SUBJECT: Police Headquarters WJE Clarification Letter – Phase 2 Peer Review Report – Life Safety Category

SUBJECT: New Police Headquarters — Phase 2 Peer Review

Findings of our structural design review of the FLPHQ building are summarized below. Only comments which warrant direct response from Thornton Tomasetti (TT), the Structural Engineer of Record (SEOR), are provided below. Items 1 through 8 are related to life safety and warrant attention either *as soon as possible* or in the near term. Suggested timeframes to complete rectifications are provided for each life-safety finding. Time frames are not provided for serviceability (Items 9 through 11) or documentation findings (Items 12 through 16), but we recommend that these items be resolved as soon as is practicable, but no later than within 12 months.

Figure 4. Detail 7 from Sheet HQ-S7-1-02 which shows CMU wall bearing on thickened slab-on-ground. Note that there is a vapor retarder under the slab-on-ground supporting the partition masonry walls

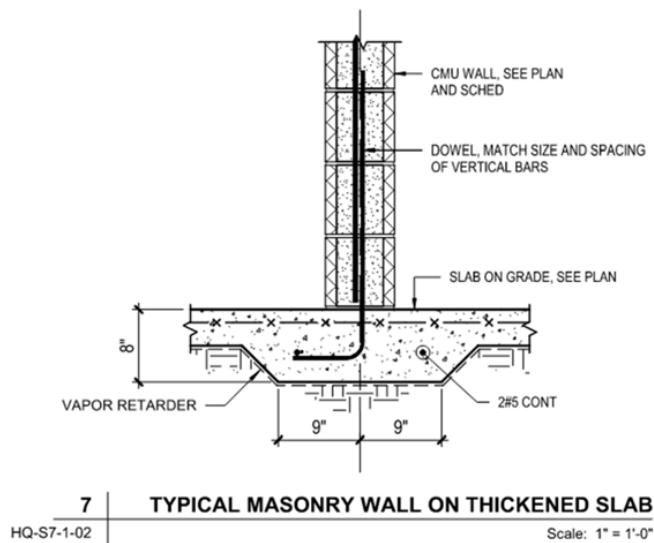
On numerous sheets in the structural drawings (e.g., Sheet HQ-S2-2-1A), the CMU partition walls are referred to as “non-loadbearing CMU” which bear on thickened slab built over a vapor retarder (Detail 7 of Sheet HQ-S7-1-02). A vapor retarder would reduce the sliding resistance of the wall.

Masonry Wall Connection Details at Top and Bottom of Wall. Both 7/HQ-S7-1-02 (Figure 4) and 2/HQ-S6-1-01 (Figure 5) indicate that the vertical reinforcement at the bottom of the CMU walls should be lapped with dowels. These dowels were to extend into the footing, or thickened slab, and be hooked. At the top of the CMU walls, two details are provided on Sheet HQ-S7-1-02, which is labeled as “Typical Masonry Details”. Detail 3/HQ-S7-1-02 appears to be a detail for use with CMU walls that are bearing walls. A note in this detail also indicates that this detail applies when tie-beams are referenced on plan. We did not observe any tie beam references on plan, and we also did not observe on the plans where any CMU walls were explicitly designated as bearing walls. As such, Detail 3/HQ-S7-1-02 appears to not be applicable to the interior masonry walls. A wall schedule shown on HQ-S6-1-01 (see Figure 6) also does not explicitly designate any of the CMU walls as bearing walls. The masonry shaft noted above would necessarily be a bearing wall as it supports the end of concrete joists, but all other walls (not within Area E) appear to be non-loadbearing walls and in fact are believed to have been constructed as infill after the concrete structure was built.

Report No. 087, Dated January 8, 2024: The TI notes that “SOG pour 4 rebar. Dowels for CMU wall need to be rearranged [sic] so that the compy [sic] with detail 7/HQ-S7-1-02 for typical masonry wall on thickened slab.” The TI also notes: “On CMU wall on lvl 1 area A grid line 4, rebar needs to be extended to the bottom of lvl 2 slab. See image on next page.” See photographs from the report in Figure 19.

Report No. 107, Dated February 8, 2024: The TI notes that "Partial inspection of slab rebar for SOG pour 5. Dowels for CMU need to be lowered to comply with what is specified on detail 7/HQ-S7-1-02." Figure 24 shows a photograph of this condition and a photograph of a CMU wall under construction. Again, note that no shoring of the structure above is present, indicating that the CMU wall was not constructed as a bearing wall.

Figure 5. Detail 2 from Sheet HQ-S6-1-03 which shows CMU wall foundation for wall footings that have WF# designation on the foundation plans. Note that the vapor retarder under the slab-on-ground does not pass under the wall footing

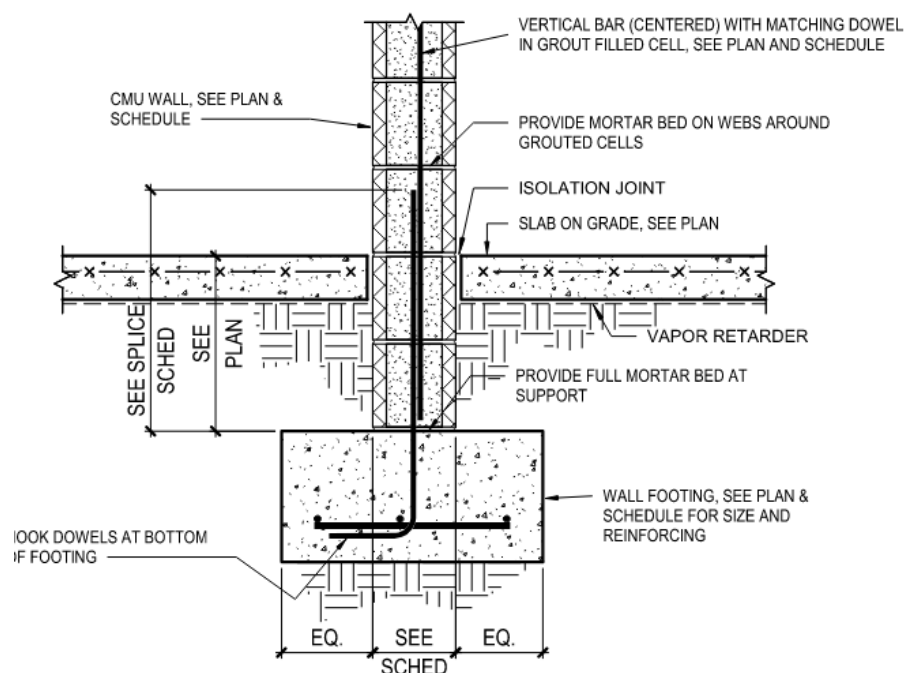
Furthermore, it is evident that the SEOR is aware of what good practices are for designing masonry shear walls, evidenced by the east-to-west spanning wall used in Area E. Unlike the partition masonry walls, that wall a) was constructed such that axial and diaphragm loads from the roof can be transferred to the wall (Figure 23), b) has vertical reinforcement that is well-anchored to develop shear-friction resistance (Figure 11), and c) has a standalone wall footing without a vapor retarder underneath it, thereby increasing the sliding resistance of the wall (Figure 5).

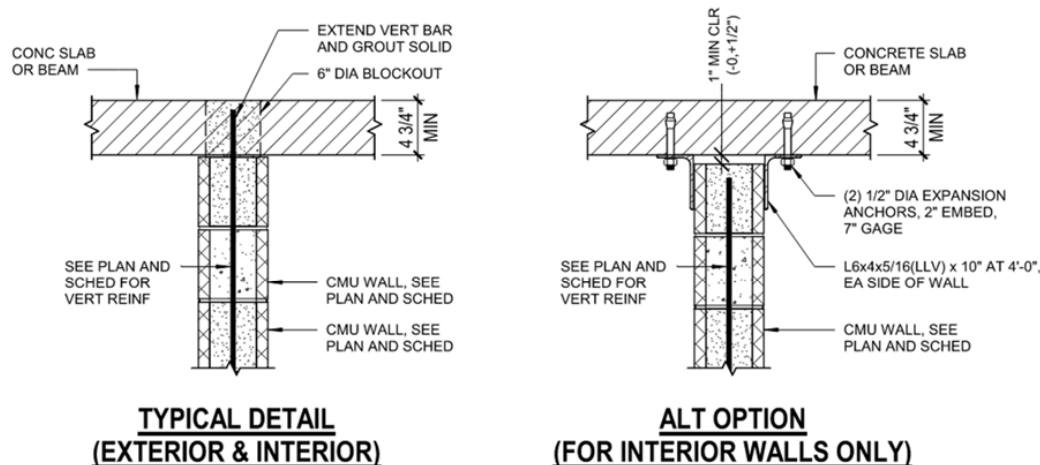
The masonry walls are not listed in the “S3 Series Drawings” which are described in the structural drawings as containing “lateral system elevations, connection forces and details.” These sections, including the shear wall schedule, refer to the cast-in-place concrete shear walls (consistent with Sheet HQ-S0-1-01), and make no mention of masonry.

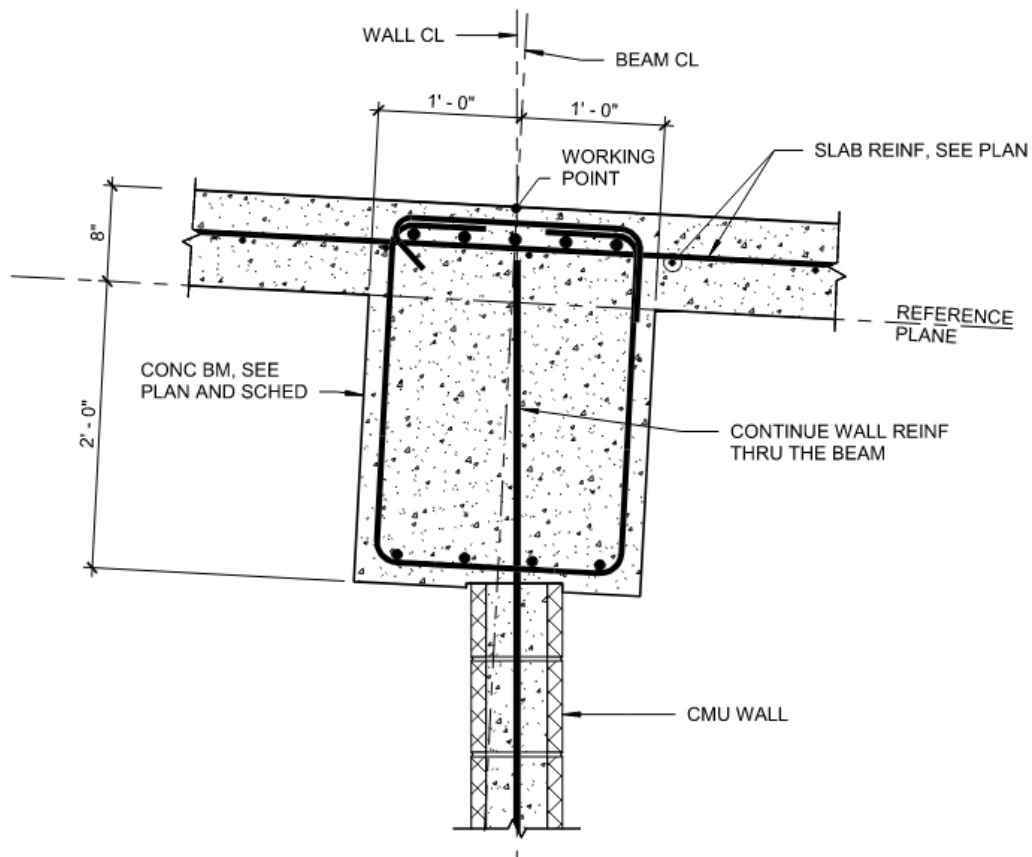
Detail 6/HQ-S7-1-02 (Figure 7) is further divided into two details, a typical detail that applies to both interior and exterior walls and an alternate option that applies to interior walls only. The typical detail shows the vertical reinforcement of the CMU wall embedded into the slab above. No minimum embedment depth is provided, but the details note that the slab thickness must be a minimum of 4 ¾ inches. Section 042200 of the specifications, “Concrete Masonry Units” Part 2.6.C addresses “Top of Wall Anchors.” This specification section is shown in Figure 8. Interior non-load bearing partition walls in Seismic Design Category A, which applies to the FLPHQ, are shown to allow PTA series anchors by either Blok-Lok or by Hohmann & Barnard (H&B). A specification sheet for PTA 420 HS anchors by H&B is shown in Figure 9. A lateral load capacity for the anchor is not provided on this sheet nor is the type of fastener (e.g., screws) required to connect the anchor to the concrete structure above. It may be that this information exists somewhere else on H&B’s website, but we could not find it. As such, it is unclear to us if these anchors are approved or rated for lateral load transfer, and if so, what load they are rated for. Also unclear is the capacity that the SEOR assumed for these anchors. A rendering of the PTA 420 HS anchor at the top of a CMU wall (also taken from H&B’s website) is shown in Figure 10. Note that the anchor is shown with the length of the top plate oriented transverse to the length of the wall, suggesting that its rated capacity would be applicable to out-of-plane rather than in-plane loading.

Figure 17. Photographs from Threshold Inspection Report No. 081. Left photograph shows overall wall construction on first story at one location. Right photograph shows the PTA anchors at the top of the wall. Note that two screws are used to connect each anchor to the above element

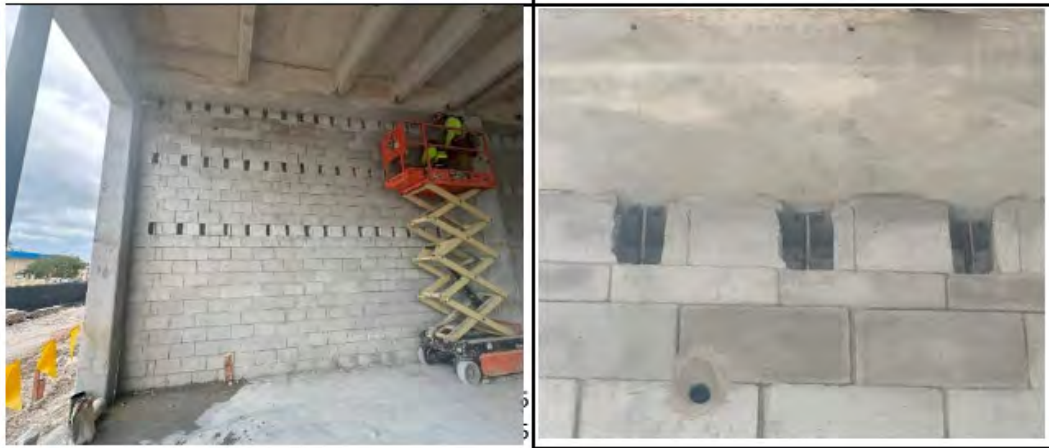
Report No. 081, Dated December 19, 2023: Comments by the TI are in regard to the concrete used in slab-on-ground Pour 3. However, photographs of CMU walls in the first story are also shown in the report (Figure 17). These photographs show the overall CMU wall construction at one location in the first story and the approved PTA anchors at the top of the wall. The length of plate at the top of the PTA anchors is aligned parallel with the length of the CMU wall in contrast with the rendering shown on the manufacturer’s website (Figure 10).

Figure 29. Photographs from Threshold Inspection Report No. 133 showing CMU wall at Level 1, Area D

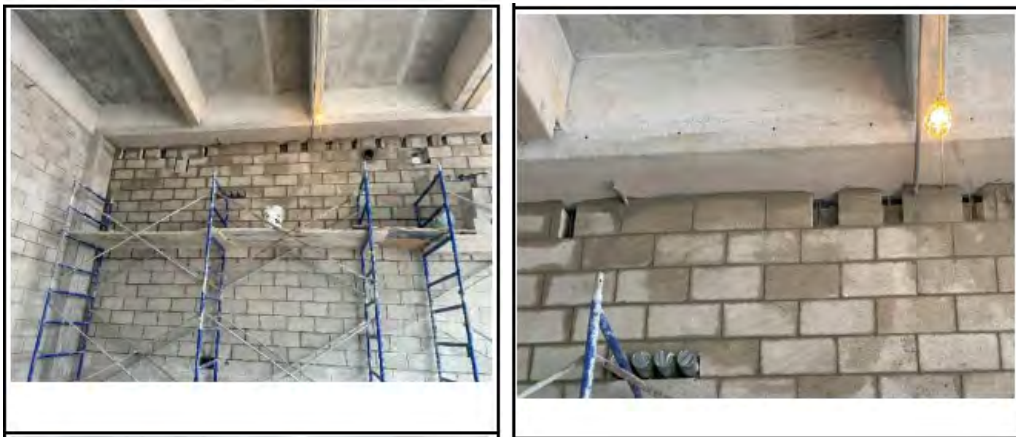
Report No. 133, Dated March 21, 2024: The TI notes that “Inspection of CMU on Level 1 area D between grid lines 15 and 16. Checked anchors are properly installed and rebar tied to them.” See Figure 29.

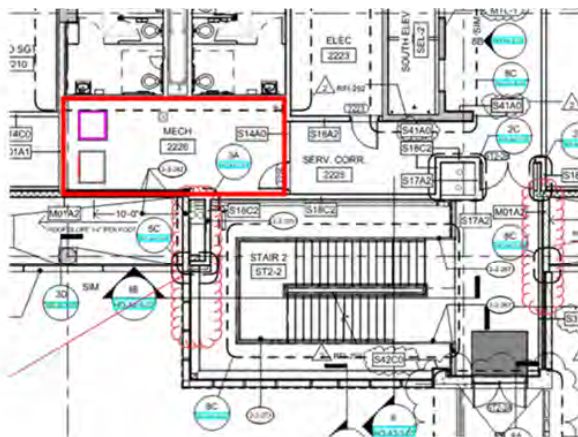
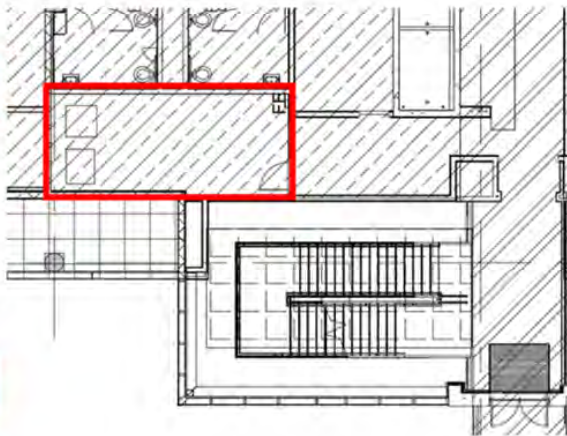
Most of the areas with mechanical equipment identified in the architectural drawings were accommodated in the structural drawings in the loading diagrams. However, we have identified one area on Level 2, south of Gridline 14, that was designated in the architectural drawings as a mechanical room but was not designated as such on Sheets HQ-S0-2-01 through 02 (Figure 30). It should be confirmed whether mechanical equipment will be installed in this area and if so, if it has been accounted for in the structural design. For our structural analysis (discussed later), we have assumed that the loading diagrams provided in the structural drawings are correct. Additionally, in some locations on the roof, both the weight of the mechanical equipment and the 150 psf allowance in live load are shown. We recommend that the SEOR confirms which load or combination of loads governed the design of the structure and specify so on the drawings. Currently, where equipment is installed, we do not know whether the equipment weight, or the specified 150 psf live load, or a combination of the two was used by the SEOR to design the structure supporting the equipment. Moreover, we recommend that the SEOR confirms if there is mechanical equipment in the area bounded by Gridlines H, J, 14, and 16 (or other areas which currently are not reflected in the structural drawings).

Figure 31. Cross-section of soffit beam (Sheet SC-3C-D of Submittal 328) showing 1.5 inches of cover to the transverse reinforcement

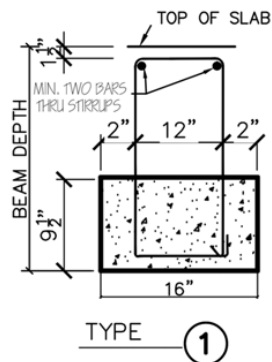
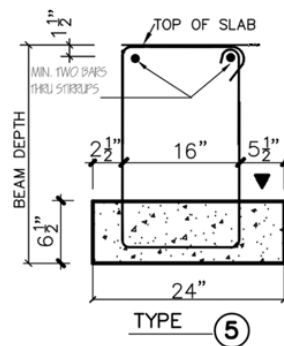
Durability. The cover depths shown in the structural drawings satisfy code-prescribed minimum values. However, the dimension lines shown in the precast concrete shop drawings (e.g., Sheet SC-3C-D of Submittal 328) were inconsistent and implied different cover depths. Figure 31 and Figure 32 illustrate one example of this inconsistency. For the first detail (Figure 31), the 1.5-inch dimension was drawn from the top of slab to the transverse reinforcement. For the second detail (Figure 32), it was drawn from the top of slab to the center of the top longitudinal reinforcement such that there was approximately zero inches of cover to the transverse reinforcement. We are unable to ascertain if what was constructed conforms to the cover requirements set forth in Figure 31 or Figure 32.

Figure 34. Plan view of FLP HQ showing the approximate locations of the center of rigidity and east-west wind loads. Due to eccentricity between the two, the structure twists

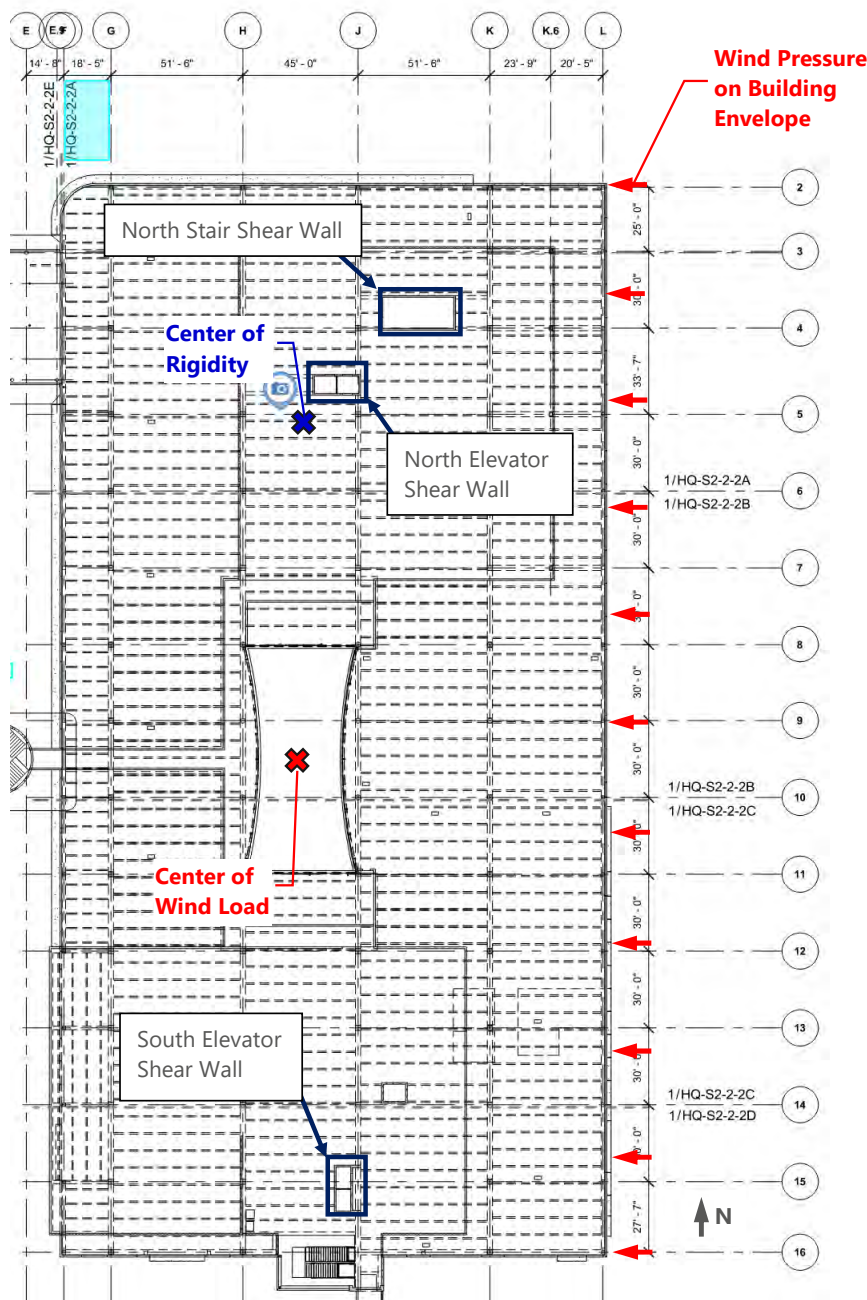
10. **Building Period.** Due to the relatively small length of shear wall in the southern half of the main building of the FLPHQ, the fundamental period of vibration of the building is over 0.9 seconds (which is significantly larger than typical concrete shear wall buildings having no more than three stories). The fundamental mode also corresponds with a twisting response of the structure. While this condition does not violate any code-prescribed performance limitations, it is not standard practice to design structures to perform this way. Adding an appropriately designed full-height shear wall (i.e., from foundation to roof) to the structure (as previously described) will rectify this condition.

length of reinforced concrete shear walls). The higher period is likely due to a) a shorter length of shear wall in the FLPHQ, and b) the differences in distribution of that wall on plan than in typical buildings of similar size, resulting in increased flexibility. The first mode shape and displaced shape of the structure when subjected to east-west winds indicate that the building is twisting in addition to laterally swaying. As conceptually illustrated in Figure 34, this twisting component of the first mode behavior is being caused by eccentricity between the center of wind loading and center of rigidity. Since there is greater lateral stiffness from the two sets of reinforced concrete core walls on the northern half of the building than the stiffness from the one set of shear walls on the southern half of the building, the center of rigidity is shifted towards the northern half of the building (approximately near Gridline 5). Moreover, since the centroid of east-west wind loading occurs roughly at the mid-length of the building, the wind loading is eccentric with respect to the center of rigidity and produces twisting. While this condition does not violate any code-prescribed performance limitations, it is not standard practice to design structures to perform this way. Furthermore, it is possible that the twisting may result in unusual serviceability-related conditions, since the lateral system of the FLPHQ differs substantially from typical practice of similarly sized buildings. Proposed measures to remediate member capacity deficiencies (discussed later) also rectify this condition.

Figure 35. Sectional view of a reinforced concrete column which is enlarged to increase resistance. Note that the new transverse reinforcement should be spaced closely to provide confinement

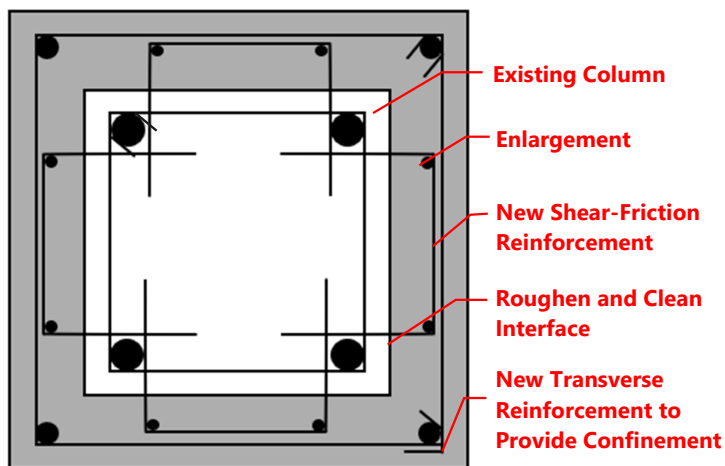
The cross section of the column can be enlarged to strengthen the column for both combined axial and flexural loading and for shear. Figure 35 conceptually illustrates the enlargement of a reinforced concrete column. Since it will be difficult to anchor new flexural reinforcement at the top and bottom of the columns due to the presence of potentially conflicting reinforcement in the soffit beams, the flexural strength of the column can be enhanced primarily by increasing the effective depth of the section rather than by adding flexural reinforcing steel.

Enlarging the cross section as shown in Figure 35 provides an added benefit of confining the concrete in the original column. When concrete is confined it has a greater strain capacity, thereby increasing the strength and ductility of the column, even without additional anchored vertical reinforcement.

In the column enlargement rectification shown in Figure 35, the perimeter of the existing column is roughened and cleaned to allow for composite action with the enlargement. New shear-friction reinforcement is post-installed into the existing column to enhance interface shear strength between the original column and the enlargement. For columns that are overstressed in axial-flexural loading, the new transverse reinforcement should be spaced closely to provide confinement. For other columns, the new transverse reinforcement need only be spaced more closely than one-half the effective depth of the column. We expect that using No. 4 reinforcing bar ties at this spacing will meet the minimum shear reinforcement provisions in ACI 318-14.

Figure 36. Sectional view of a reinforced concrete column which is wrapped with FRP to enhance shear strength and member deformability

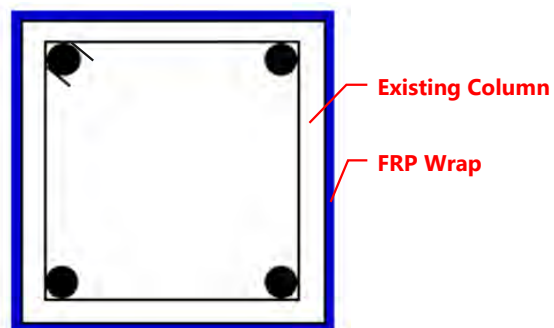
Fiber-reinforced polymer (FRP) jacketing of the columns may also be a viable option to rectify the axial-flexural and shear conditions previously identified. As illustrated in Figure 36, this rectification entails wrapping a column with FRP and adhering it using epoxy. FRP jacketing can be used to provide

Figure 37. Section view of a reinforced concrete beam which is enlarged to increase flexural resistance

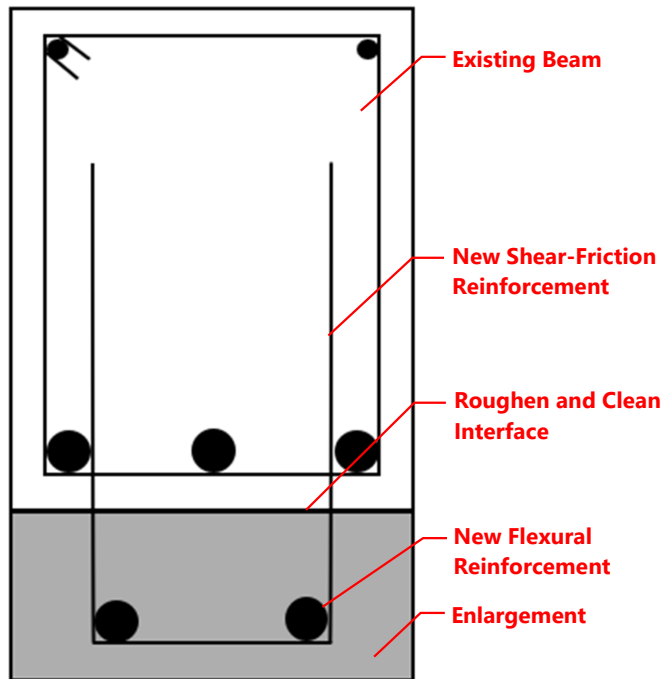
Enlarging the overstressed beams can enhance their flexural strength, similar to the upturned beams on roof soffit beams RSB 76 and 79. A conceptual illustration of this type of rectification is shown in Figure 37. The tension-face of the existing beam is roughened to allow for sufficient interface-shear strength with the new enlargement. Post-installed U-shaped ties embedded (at least one development length on either side of the interface) are provided to enhance interface-shear strength. Adequately anchored tension reinforcement is provided in the enlargement to increase flexural resistance of the beam.

Figure 38. Section view of a reinforced concrete beam showing strengthening with near-surface mounted reinforcement (adapted from ACI 440.2-23)

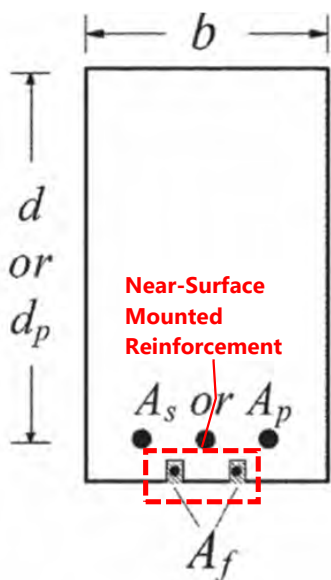
Similar to beam enlargements, a near-surface mounted (NSM) rectification entails providing new longitudinal tension reinforcement to increase the flexural strength of the overstressed beams. As shown in Figure 38, grooves are cut into the existing beam to receive the new reinforcement. The substrate within the groove should be properly prepared to enhance bond strength with new epoxy or cementitious paste which is placed in the groove with the reinforcement. Steel reinforcement may be used, although non-metallic reinforcement or corrosion-resistant metals may be preferable to mitigate the risk of corrosion.

Figure 39. Section view of a reinforced concrete beam strengthened with an externally bonded FRP laminate (adapted from ACI 440.2-23)

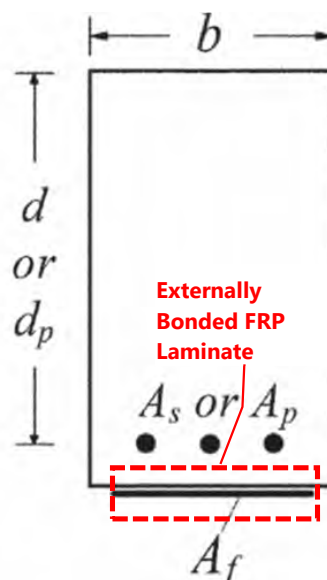
Other externally bonded systems may be utilized to increase the flexural resistance of a beam. ACI 440.2-23 also provides guidance for designing other external FRP systems, such as bonded laminates (Figure 39). Otherwise, a steel plate may be bonded to the beam but would likely require fireproofing. No matter the system used, sufficient anchorage of the external system should be provided such that it may develop its intended strength at the critical regions requiring strengthening.
